Decision re Mann Town Highway Access Road Permit Application

I am writing to request reconsideration and clarification of two (2) provisions of the Memorandum of Decision and Driveway Permit with Conditions and Limitations issued to Andrew Mann on October 13, 2023.

Request for Clarification and Reconsideration of the Driveway Area Dimensions

SHEET TITLE: SLIDE #6 - 19' WIDE X 20' DEEP HELD TO NORTH EXTENT

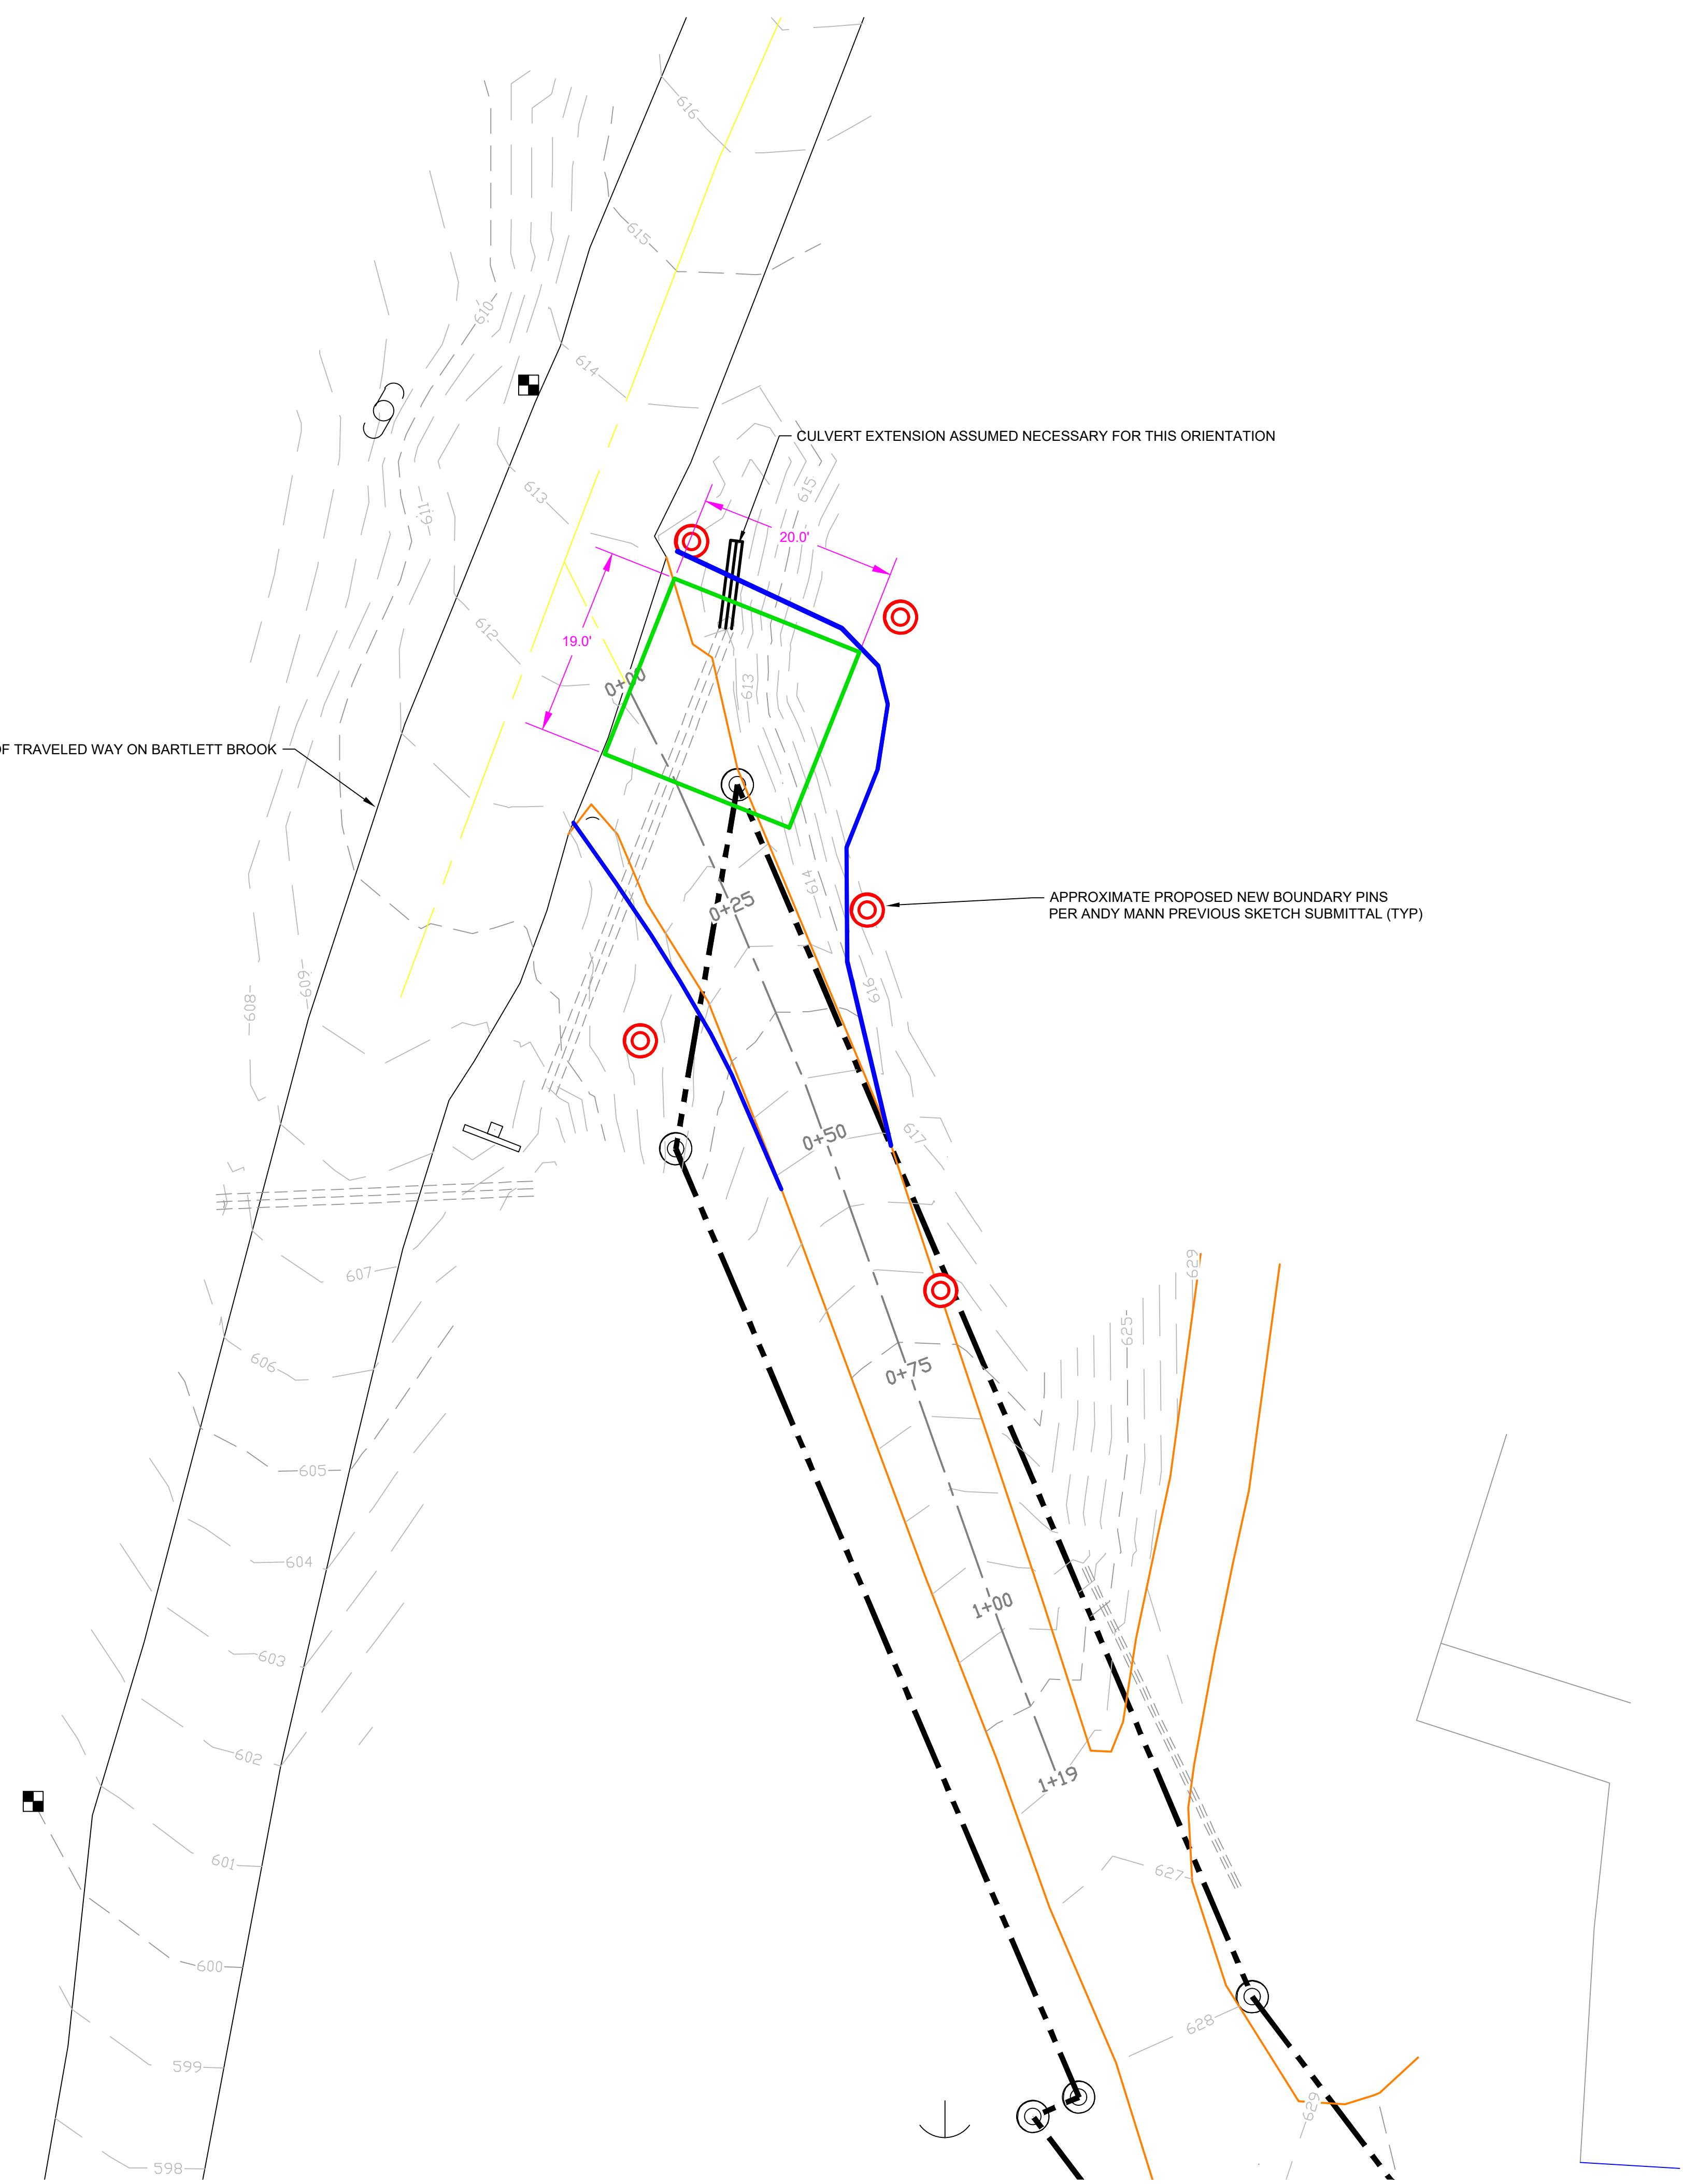
Alternatively, if either a 17' or 19' box is located at the northern end of the Revised Site Plan (as set forth in Slide 4 and Slide 6) abutting the proposed (and approved) Dinsmoor Road travel way to the north, the southern end of the driveway entrance is located almost in the middle of the proposed travel way which is inconsistent with Mr. Mann's testimony and potentially changes what the Select Board contemplated in Conditions F and Condition G given that it is unclear what work would be contemplated between the edge of the green box and the southern edge of Mr. Mann's proposed travel way in his site plan.
